V2500 Propulsion System — Engine

SERVICE BULLETIN

Subject: Transmittal of Revision 1 to Service Bulletin Number V2500-ENG-79-0042

ENGINE — POWERPLANT - INTRODUCTION OF A NEW MAGNETIC
CHIP DETECTOR

LOCATION OF MCD ASSEMBLIES
FIGURE 1

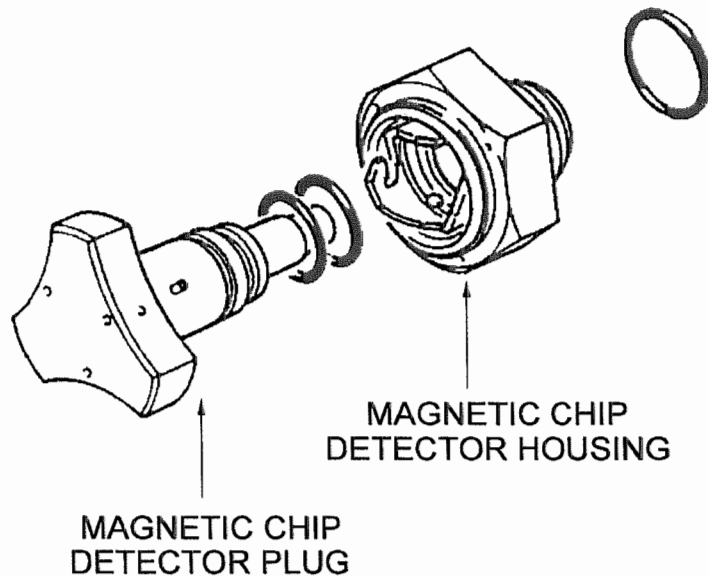
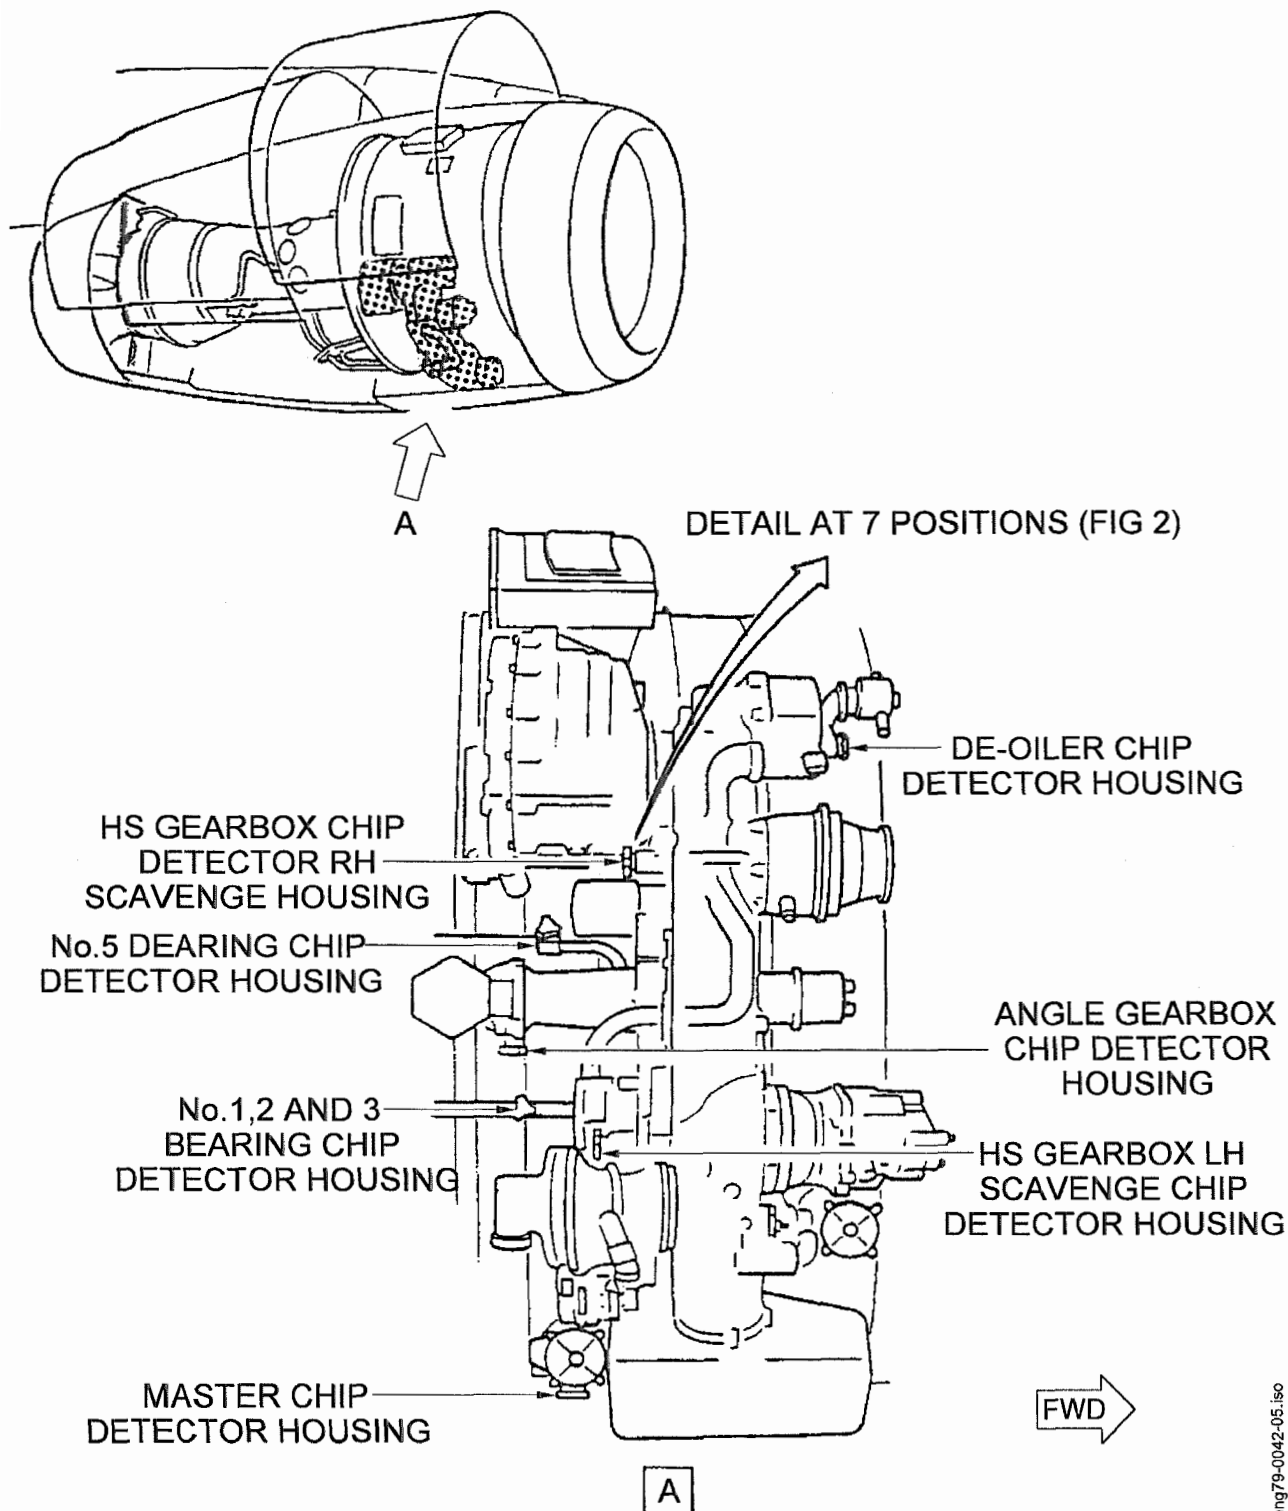
- (4) Repeat steps (1) thru (3) as necessary for the replacement of the MCD Assemblies at the locations listed below. Refer to Figure 1:
 - * HS Gearbox Chip Detector RH Scavenge Housing

- * No. 5 Bearing Chip Detector Housing
 - * No. 1,2 and 3 Bearing Chip Detector Housing
 - * De-oiler Chip Detector Housing
 - * Angle Gearbox Chip Detector Housing

- * HS Gearbox LH Scavenge Chip Detector Housing
- (5) Make sure there is sufficient oil in the system. Refer to the Aircraft Maintenance Manual, Task 12-13-79-610-011.

REPLACEMENT OF MCD ASSEMBLIES
FIGURE 2

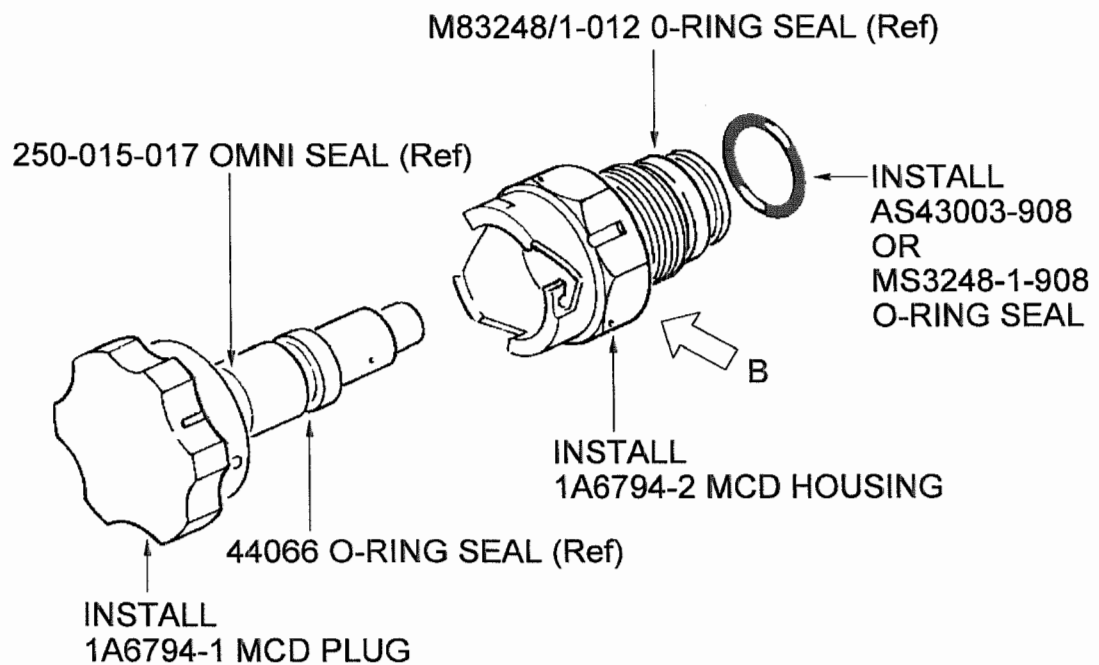
Note: Do not remove or replace the O-Ring Seals or Omni Seal from the new MCD Assemblies. The new MCD Assemblies are delivered with a 44066 O-Ring Seal, an M83248/1-012 O-Ring Seal and a 250-015-0107 Omni Seal installed (ref: Figure 2).

REMOVAL OF P/N VB3505 PLUG, P.N VB3522-2 HOUSING
AND O-RING SEALS

INSTALLATION OF THE 1A6794 MCD ASSEMBLIES
TYPICAL OF SEVEN POSITIONS

- (1) Install the new AS43003-908 or M83248-1-908 O-Ring Seal to the new 1A6794 MCD Assembly. Refer to the Aircraft Maintenance Manual, Task 70-23-13-911-010.

- (2) Install the 1A6794 MCD Assembly as instructed in the Aircraft Maintenance Manual, Task 79-22-45-400-011. Torque the 1A6794-2 MCD Housing to 225 to 250lb in (25.4 to 28.25 Nm).

- (3) Lightly pull the 1A6794-1 MCD Plug and try to turn it clockwise and then counter-clockwise. The MCD Plug must stay locked. Make sure the red index alignment mark on the Plug aligns with the red index alignment mark on the Housing.
